DESIGN & ACCESS STATEMENT: ADDENDUM

Canalside,
Oxford North

On behalf of Hill Residential

2.0 Original Planning Approval Ref: 18/02065/OUTFUL

Figure 19. Proposed Bike Store 2. (94 spaces).

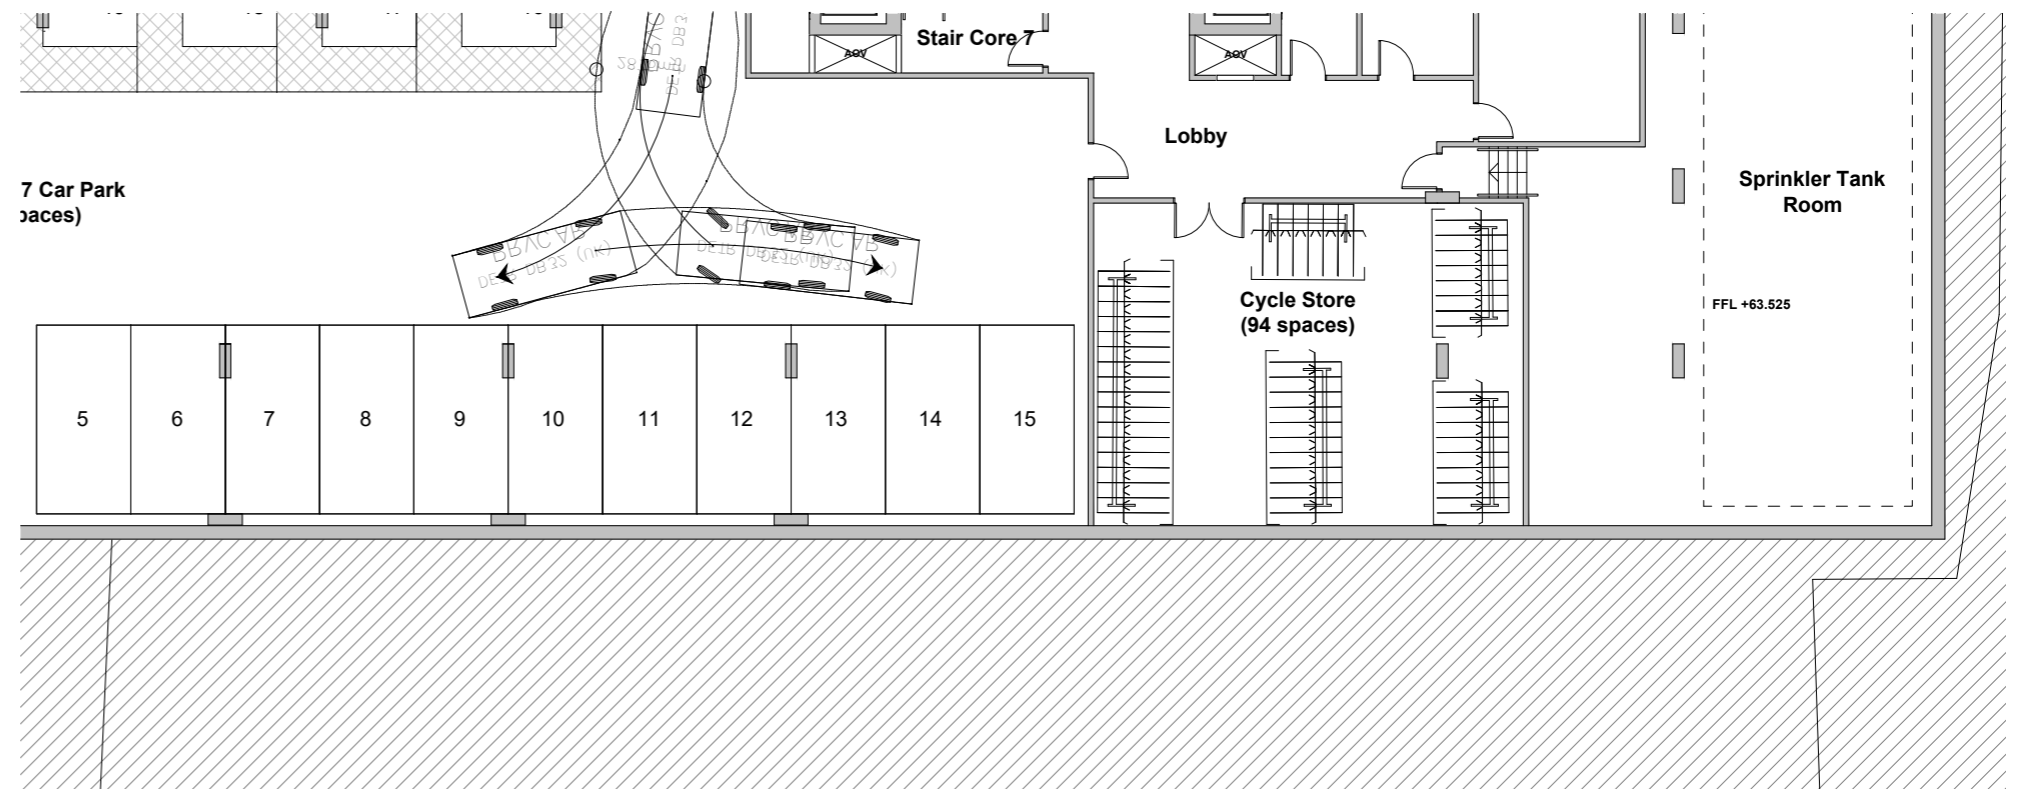
The revised scheme relocates the bike storage to the basement level, with one store located to the side of the access ramp providing 40 spaces and a larger store located to the south-eastern end of the basement providing a further 94 spaces.

Figure 21. Extract of revised Landscape Masterplan, with the cycle store footpaths omitted.

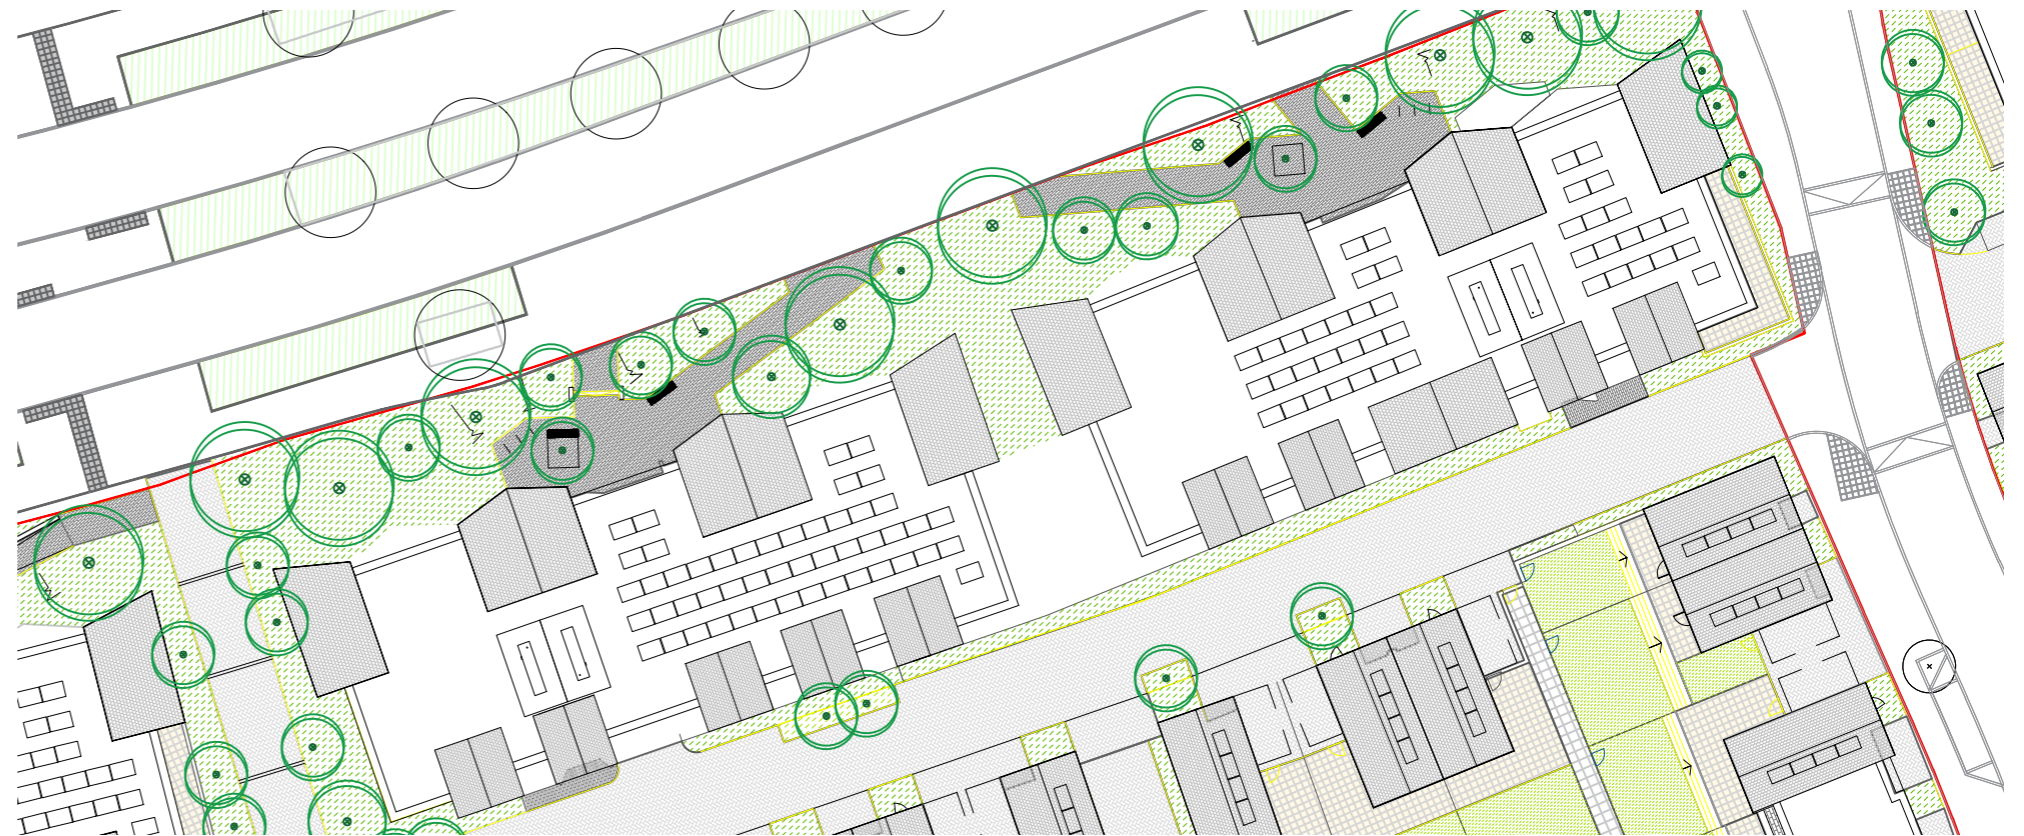
Changes to the Landscaping is minimal, with the proposed omission of the two paths leading to the Bike Store entrances previously located to the North East of Blocks 6 & 7.

Figure 22. Extract of revised Ground Floor Plan, showing the location of the 2 additional flats.

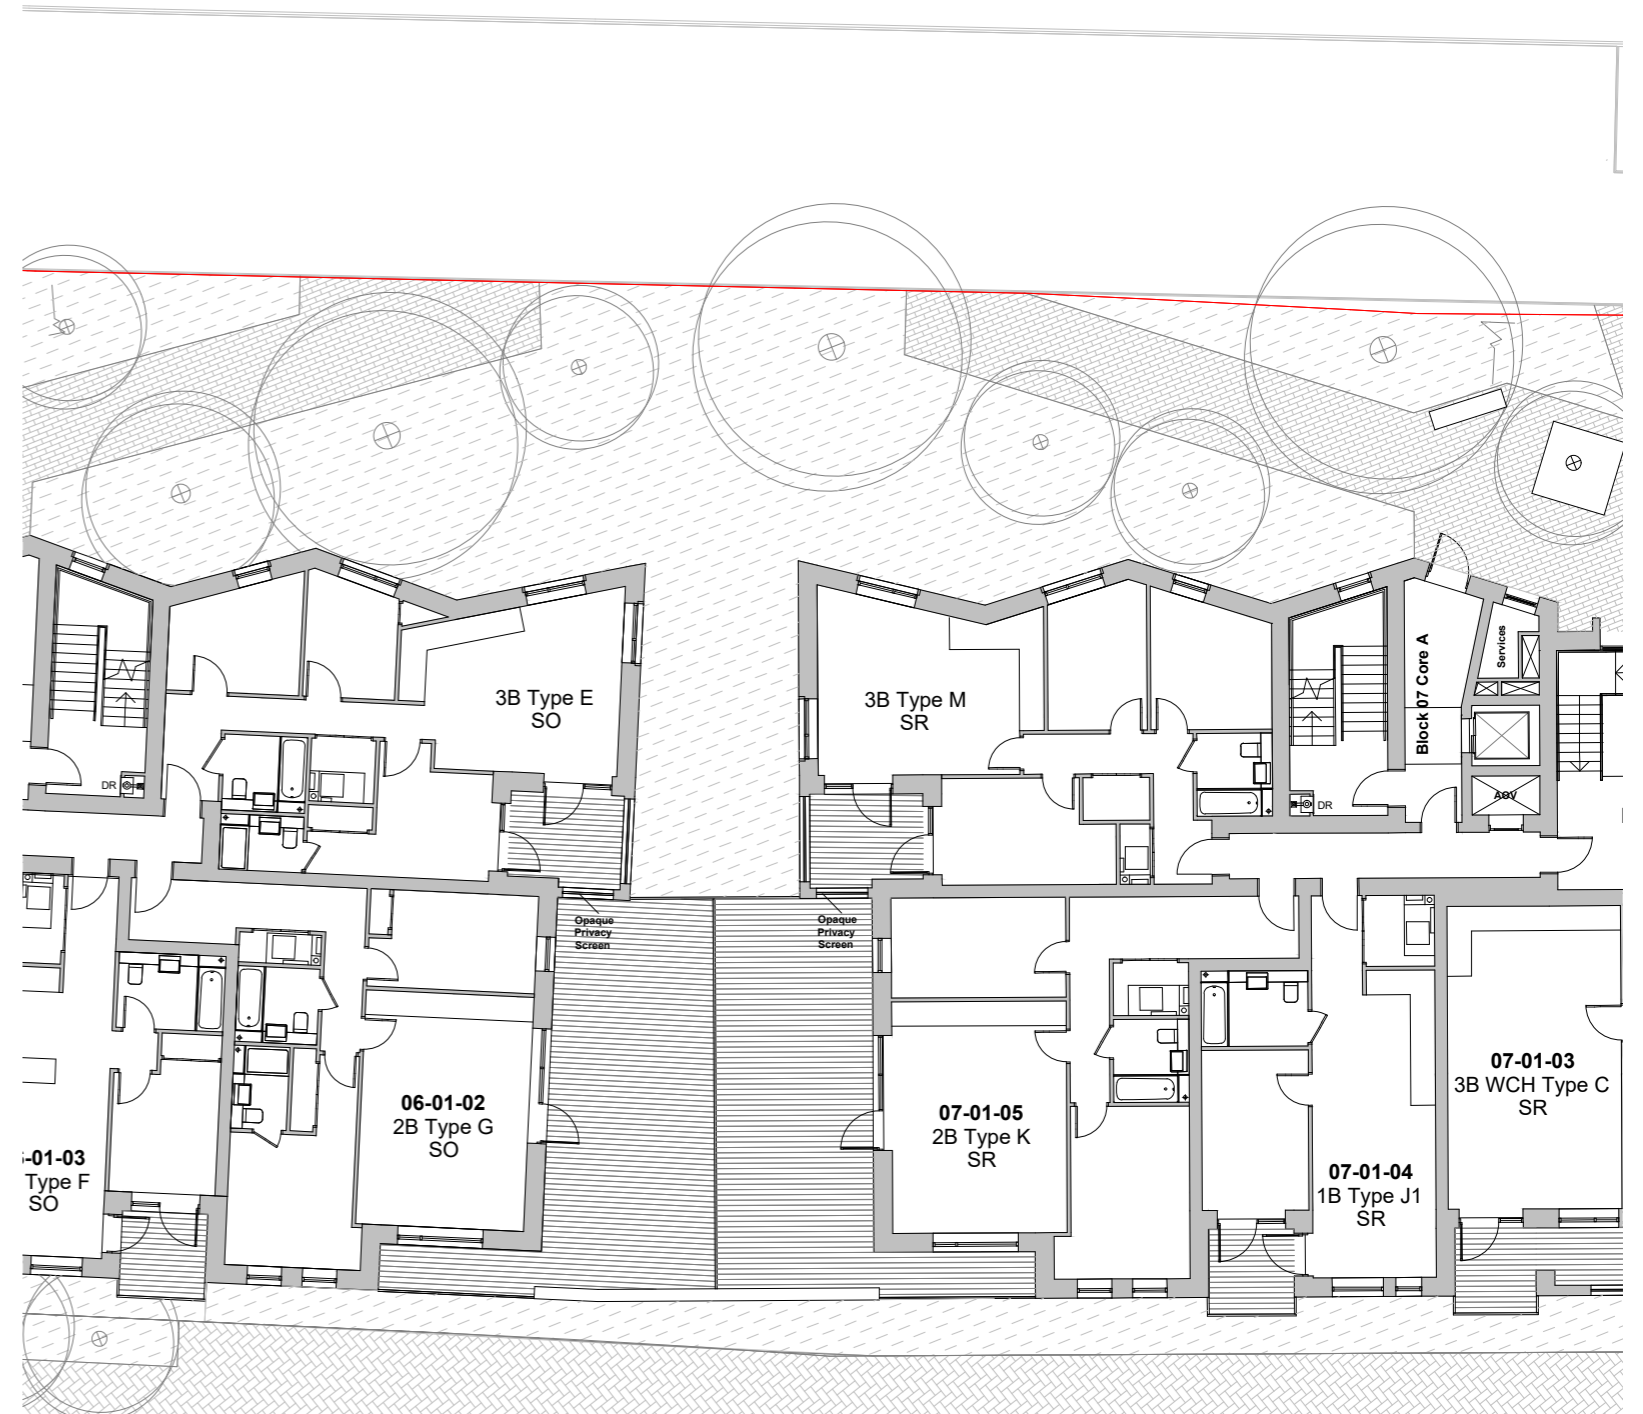
The proposed revisions seek to include 2 additional 3-Bedroom flats to the ground floor of Blocks 6 & 7.
